— 31/6-95J 10415 Howard Street —
(Kensington Historic District.)

MEMORANDUM

SUBJECT: Historic Area Work Permit

EXPEDITED HISTORIC PRESERVATION COMMISSION STAFF REPORT

ELECTRICAL LIGHTING PLAN	
KENSINGTON STATION HANDICAP ACCESS RENOVATIONS	
DMJM DANIEL, MANN, JOHNSON & MENDELHALL <small>INC. 10 CHARLES STREET, SUITE 1000 NEWTON, MASSACHUSETTS 02459 (617) 552-1100</small>	
DESIGNED	LRB
DRAWN	LRB
CHECKED	MM
DATE	11/7/84
SCALE	AS SHOWN
DRAWING NO.	E-2

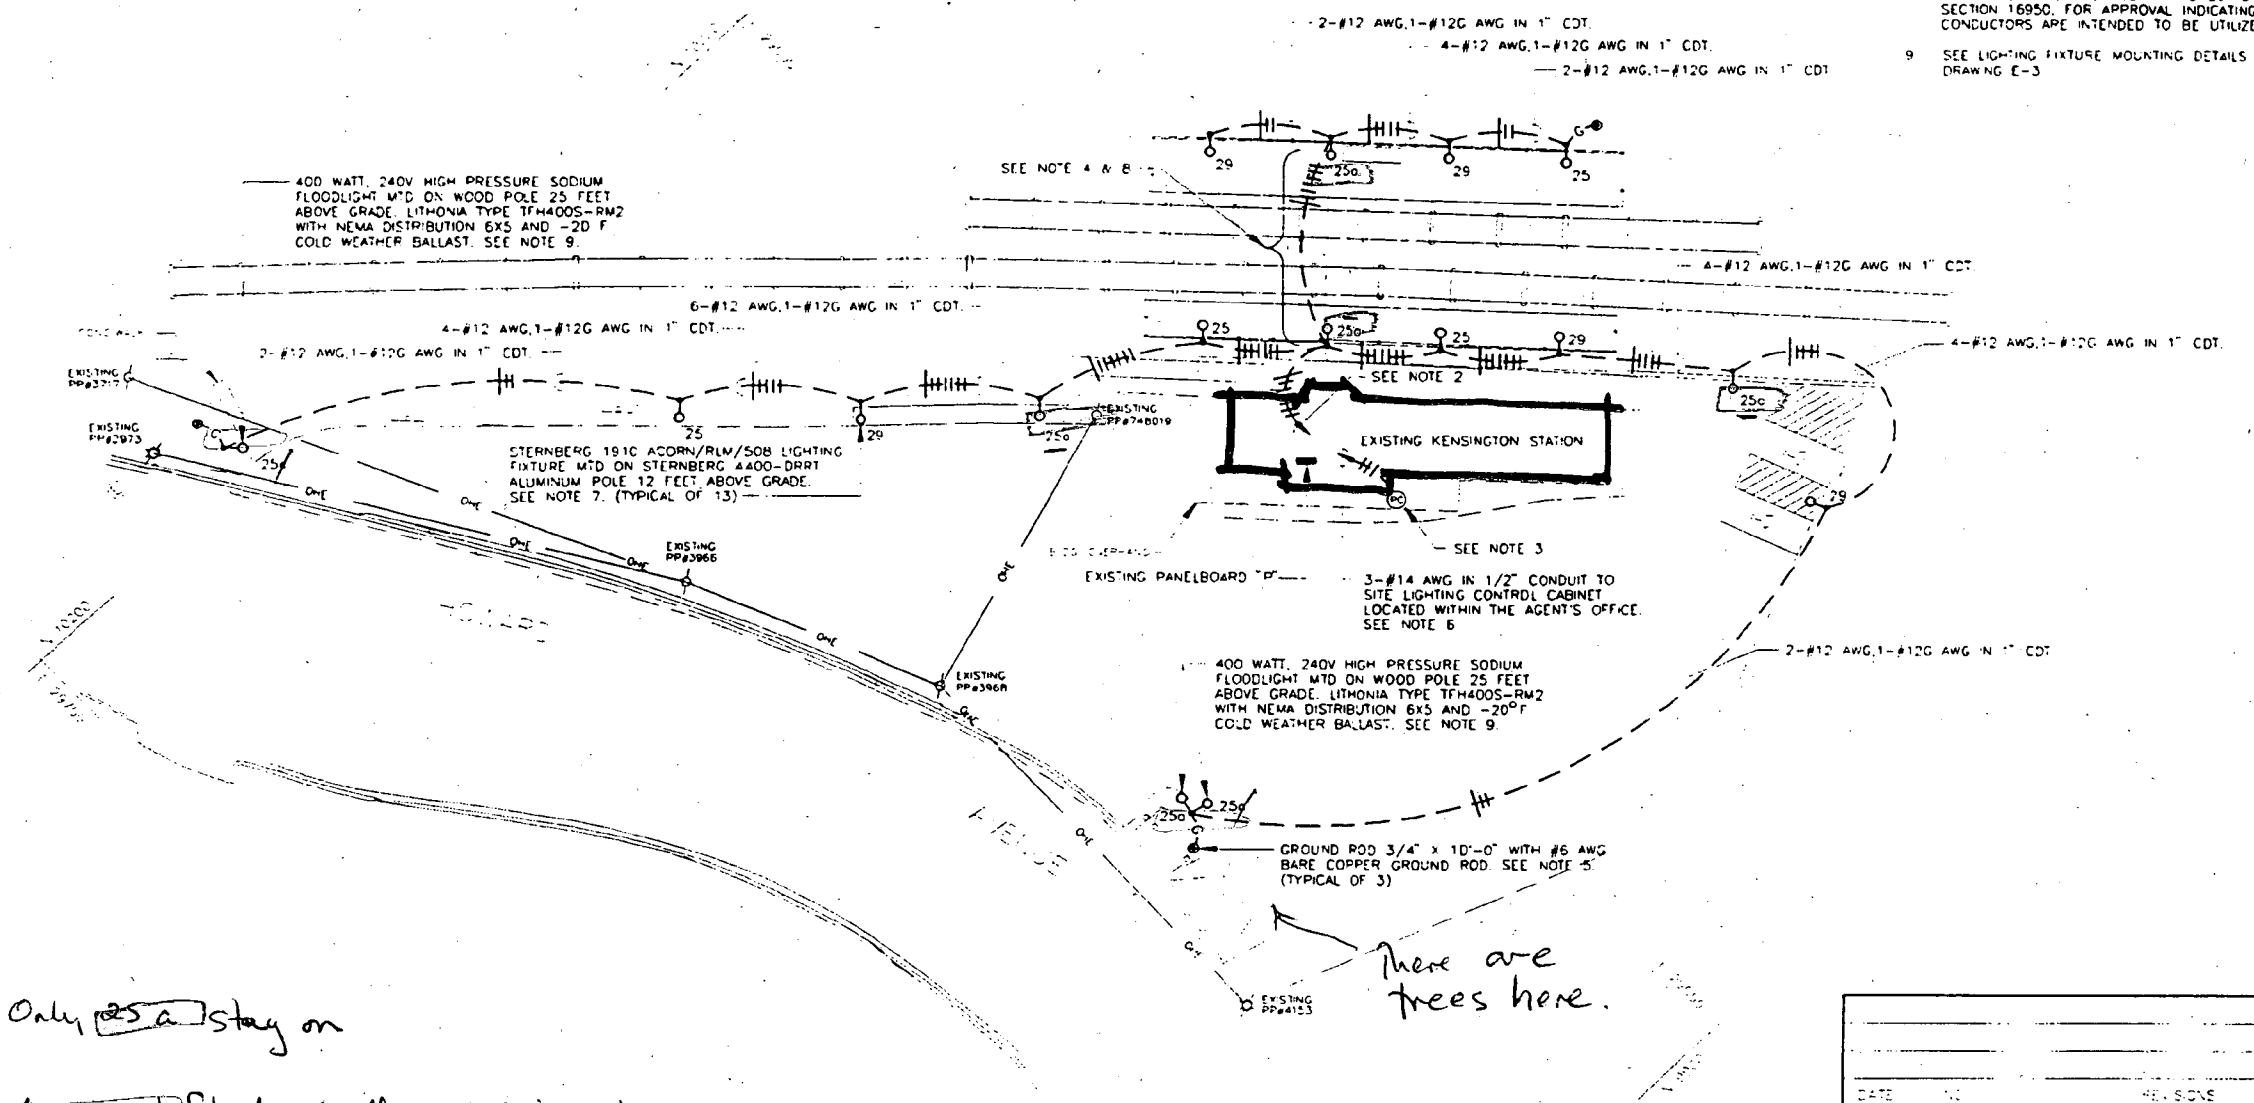
The LAP met on Thursday, and called up with questions about the levels of illumination, and the color of the light, and the possible effects on the residents on Montgomery Avenue.

The wattage = 100 watt
high pressure
sodium -

How bright?

What color light? - 47

Will they be local or
Flat Black finish

- (1) Use the minimum wattage necessary;
- (2) Direct all lights away from houses on Montgomery Avenue.
- (3) Achieve a white light rather than a yellow light

③ White light not yellow - (Metal halide light)
① Minimum wattage
② Directed away from horses -
